Access Compliance Report

Public Rights-of-Way

(Curb Ramps)

Intersection ID: 11619	Main Street: E_15TH_ST	Cross Street: N_CALDWELL_ST	Location: S
ADA ID: BB6225F2F051	Ramp Type: PerpDiag	Initial Pass/Fail: Fail	Overall Compliance: No
		Severity Score: 35

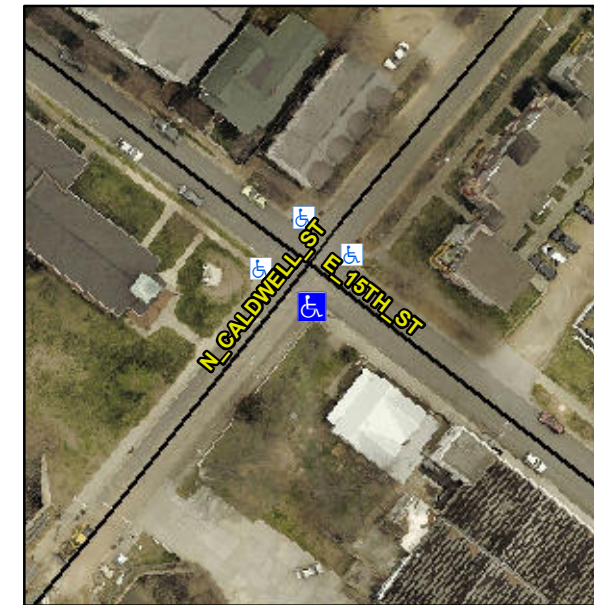
Not Found, R304.5.1

Remove & Replace Curb Ramp With Two New Directional Ramps or Equivalent.
